**Re: Comments regarding the Application of Vulcan Construction Materials LLC for Edwards Aquifer Permit No. 13001906.**

## Technical Comments – TCEQ Water Pollution Abatement Plan (WPAP) Far South Mining LLC - Needmore Quarry Ranch

Blue Creek Consulting LLC has prepared the following technical comments regarding the TCEQ Water Pollution Abatement Plan (WPAP) prepared for Far South Mining LLC - Needmore Quarry Ranch, dated 9/1/2023, prepared by Westward, Boerne (TCEQ reference numbers 11003759 and 11003760).

**Figure 1. Quarry locations are shown with reference to outcrops of units correlative to the Edwards and Trinity Groups. Surface geology is from the USGS . Recharge zone and Edwards Aquifer Authority jurisdiction outline is from the EAA.**

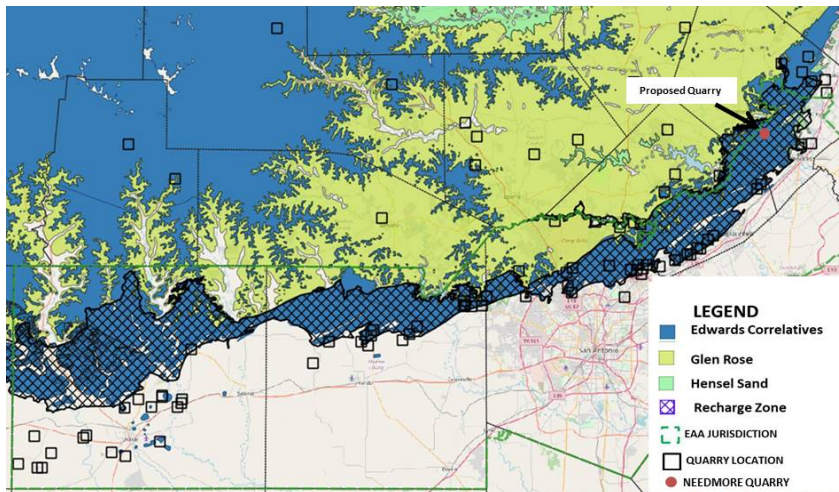
The Edwards limestone has been quarried extensively in the recharge zone of the San Antonio segment of the Edwards Aquifer, and the proposed Needmore quarry falls in that trend (Figure 1). Studies of nitrate in the Edwards Aquifer have noted that levels are elevated above an expected background level of 4.4 mg/L nitrate as NO<sub>3</sub> (1 mg/L nitrate as N) or less (Dubrovsky and others, 2010) but not offered an explanation, e.g., Bush and others, (2000). More recently, Musgrove and others (2016) ruled out contributions of nitrate from surface water and agriculture as causes of the higher measurements. Instead, they concluded that high nitrate levels in the eastern part of the San Antonio Segment result from urbanization on the recharge zone since 2000. However, they lacked historical data on nitrate concentrations and did not use data from rural counties to the west where they expected concentrations to be low.

Quarrying of the Edwards Limestone in the recharge zone has been intense for at least 80 years (Forster, 2010) and covers the entire extent from Hays to Uvalde counties (Figure 1). Both distribution and timing of elevated nitrate measurements show quarries are necessary to explain the increase in nitrate in the Edwards Aquifer. In particular, the increase in nitrate concentrations throughout the San Antonio Segment (Figure 3) fits well with the history of ANFO use. ANFO was introduced on large scale to the explosives market in the mid 1950's and dominated the market by the 1960's (Moreira, 2012). Levels have continued to rise coincident with increase in aggregate production. Recently measured levels mostly remain below concentrations harmful to humans which is 44 mg/L N as  $\text{NO}_3^-$  (10 mg/L N), but most measurements are above 8 mg/L N as  $\text{NO}_3^-$  (2 mg/L N) which is harmful to some freshwater aquatic organisms (Monson and others, 2016).

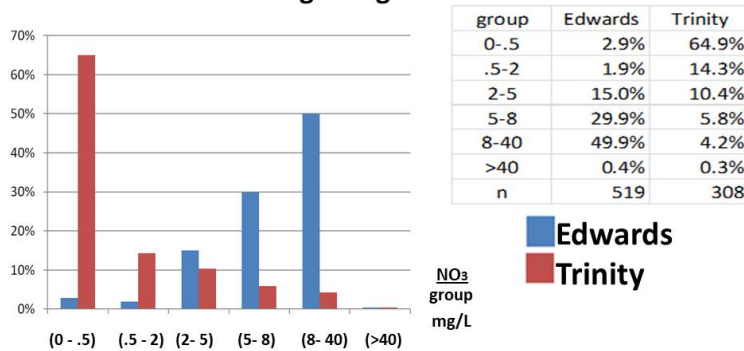
Data from the Texas Water Development Board show urbanization alone cannot explain the geographic distribution of nitrate as shown by elevated concentrations in Medina and Uvalde counties (Figure 2). Besides surface water, the Edwards Aquifer is charged by cross-fault flow from the Trinity Aquifer which is clearly lower in saturation than the Edwards (Figure 2). Also, by the 1960's nitrate levels were elevated compared to background levels observed in the 1940's and 1950's, and levels have continued to increase since (Figure3). So, an additional explanation is required for both geographic distribution and timing of

**Figure 4. The proposed Needmore quarry is crossed by a fault (Clark and Others,2018) and nearby karst features (Wierman and Hunt, 2010) make it likely that a well developed fracture system will be present.**

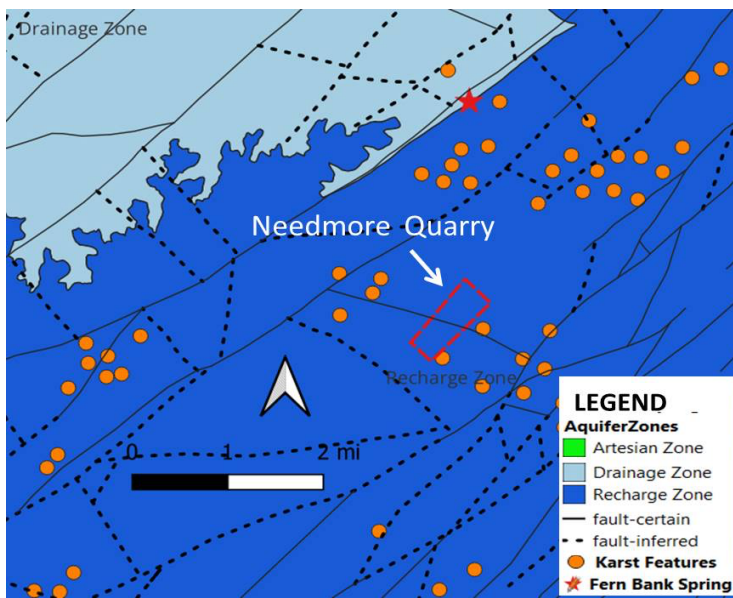
The geological report in the Needmore WPAP reported no sensitive features, even though the USGS mapped a fault crossing the proposed quarry (Figure 4). Faults will commonly have a zone of deformation including fractures that may be several hundred feet wide (Ferrill and others, 2011). The prevalence of karst features aligning with faults and in close proximity to the proposed quarry make it likely that a natural fracture system will be encountered. During the course of mining induced fractures from blasting will enhance passage of

dissolved nitrate to the aquifer. Decreasing the distance between the quarry floor and the aquifer will increase that risk as well (Polemio and others, 2009). In short, with no modifications to the proposed WPAP, the Needmore Quarry will contribute to the problem of rising nitrate concentrations in the Edwards Aquifer.
